David Garrett & Associates

RE: Response to Regulatory Review Comments
Buffaloe LCID Landfill and Processing Facility
NCDENR Solid Waste Permit #92-O and 92-23

On behalf of the Buffaloe family and the Buffaloe LCID facility, I am pleased to present the following responses to your comments pertaining to the referenced project, which you presented in an e-mail to me dated July 20, 2010. The responses are presented in the order received.

DRAWING TITLE:
**FACILITY PLAN WITH
1/4 MILE LOCAL AREA MAP**

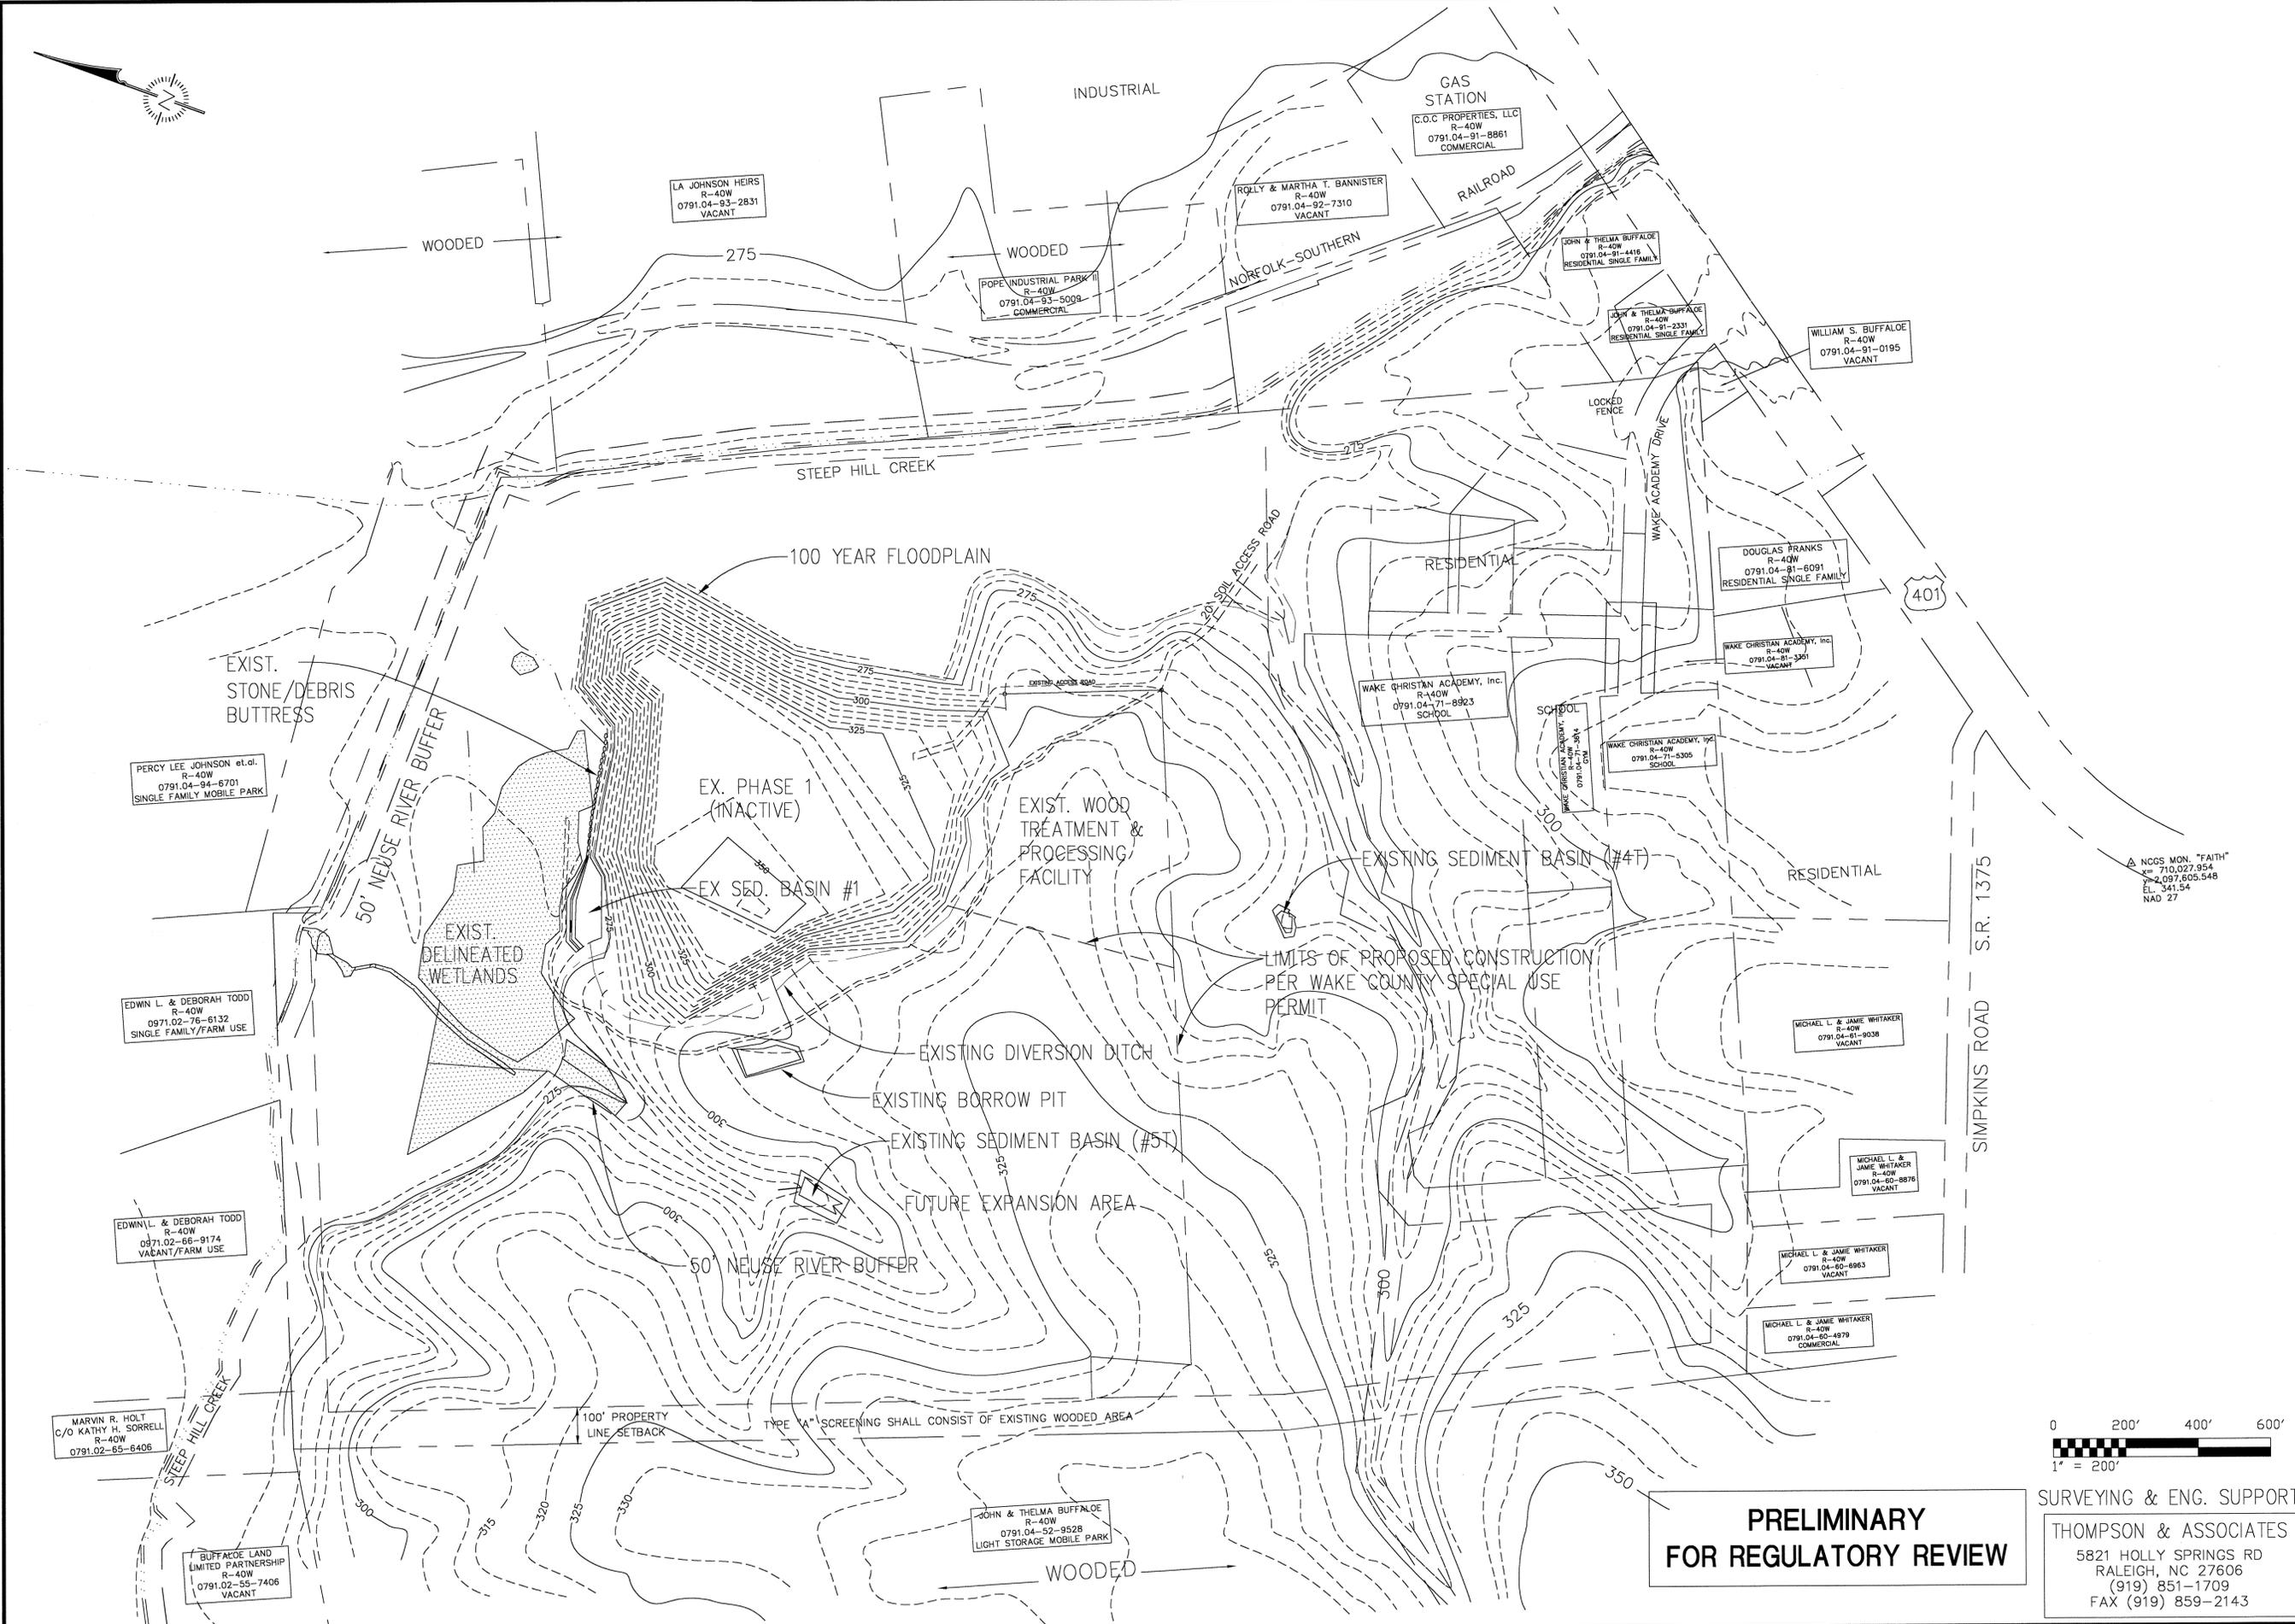
4). The north arrow on your “Facility Plan with ¼ Mile Local Area Map” points to a wrong direction.

Please refer to Figure 2, which is the same drawing (north arrow corrected), showing the approved Phases 2 – 7 and the proposed future southward expansion.

DRAWING TITLE:
CROSS SECTIONS

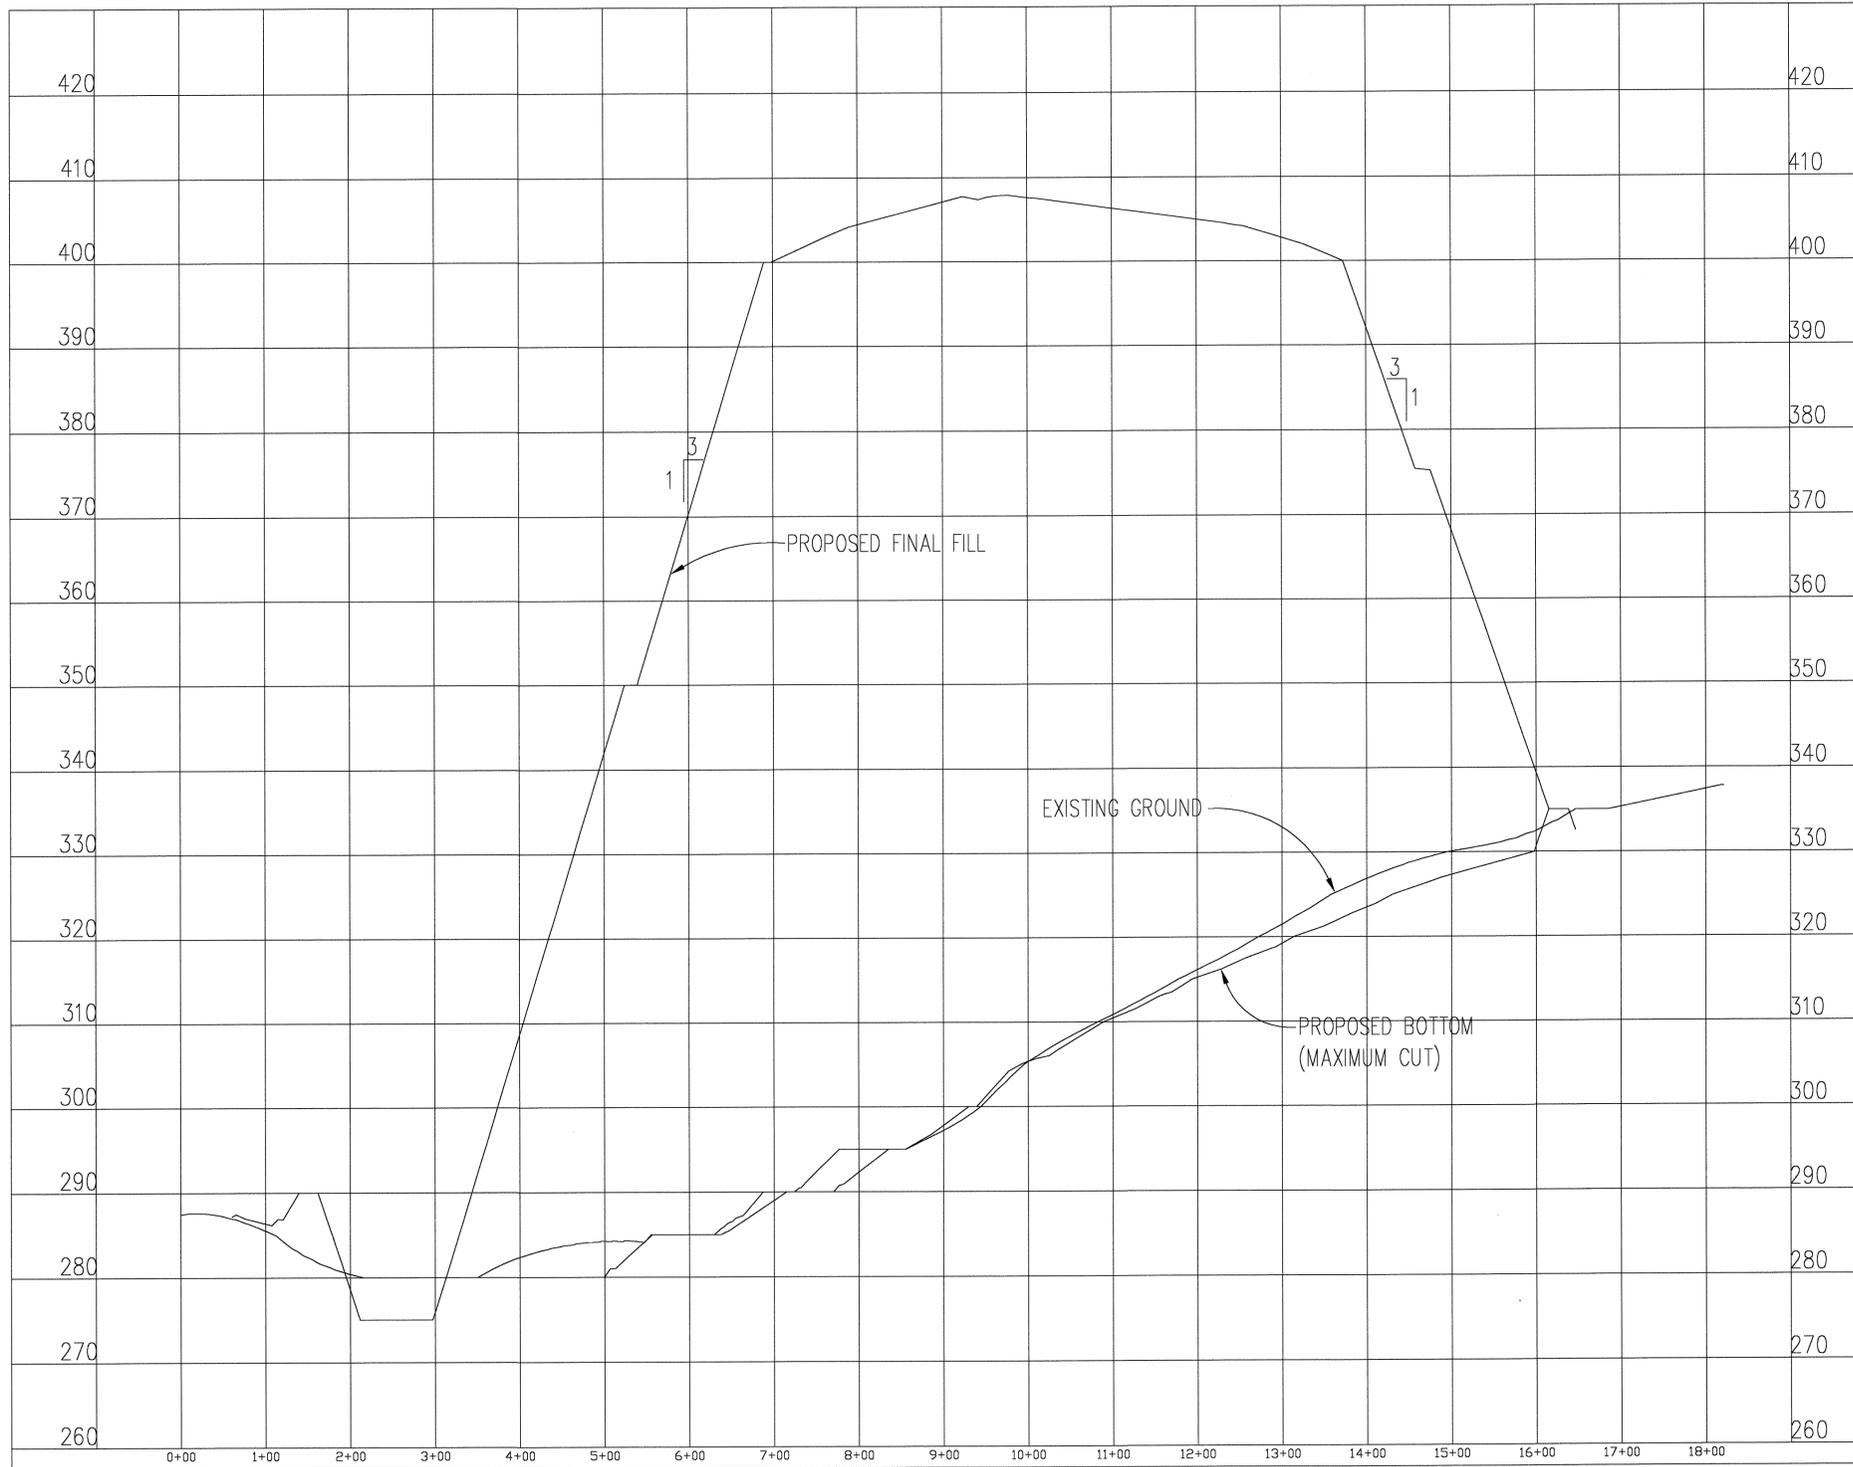
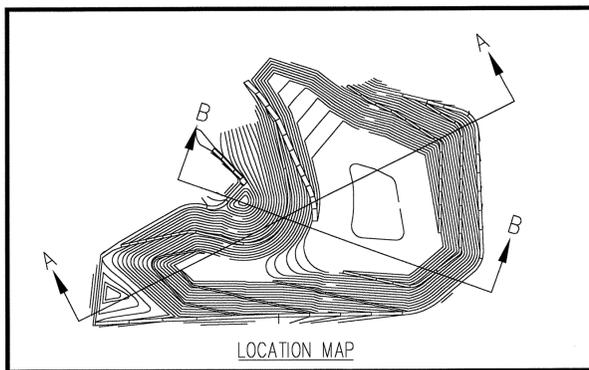
2). Please include the landfill's cross-section profiles A-A' and B-B' drawings in Attachment 1 to illustrate the landfill facility's air-space layout and capacity. Would you please provide us the electronic (PDF) file(s) of the cross-section drawings?

The cross sections are furnished electronically with the entire set of 2001 permit drawings, prepared for Wake County (see **Attachment 2**). As a point of clarification, the disposal unit (Phase 1) was originally permitted by Wake County under authority from NC DENR, while the T&P facility had a permit from NC DENR. The facility boundary for neither coincided with the property boundary. During the course of preparing the closure of Phase 1 and the expansion application for Phases 2 – 7 (both of which were approved by Wake County), the facility boundaries were combined and shown to coincide with the property boundary – see **Figure 1**, prepared by Thompson & Associates, August 2001. Following customary practice under the Solid Waste rules, the 2008 application for the permit renewal showed the property boundary as the facility boundary. Based on the older drawings, I determined the following:
